Class 1 Permit Modification

Revise Permit to Correct References, Inconsistencies and Figures

Waste Isolation Pilot Plant Carlsbad, New Mexico

WIPP HWFP #NM4890139088-TSDF

Figure L-10
As-Built Configuration of Well WQSP-1

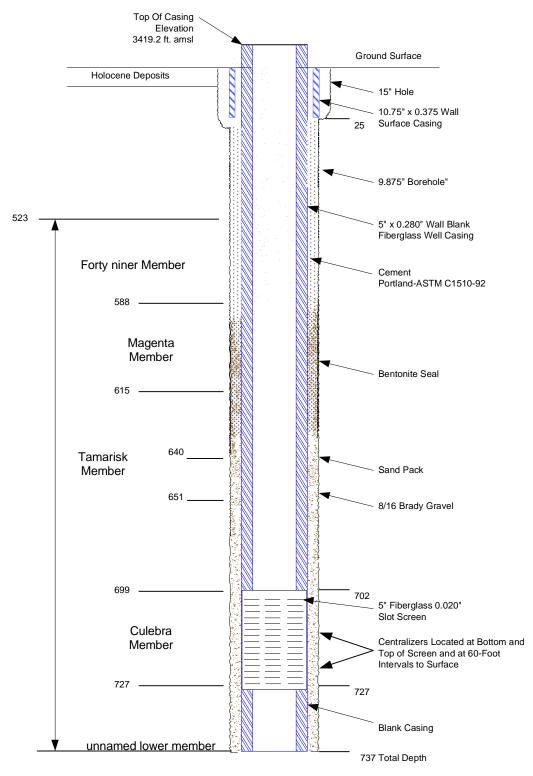
Revise the table in Module V and figures in Attachment L to reflect new coordinates and elevations based upon a recent well survey.

The monitoring wells for the WIPP facility have recently been re-surveyed as requested by the NMED Groundwater Bureau on October 17, 2006. This data has recently been transmitted to the NMED with a commitment to supply a Class 1 modification updating the appropriate table and figures in Module V and Attachment L of the HWFP. This modification complies with that commitment.

b. Revised Figures L-10 to L-16 are attached.
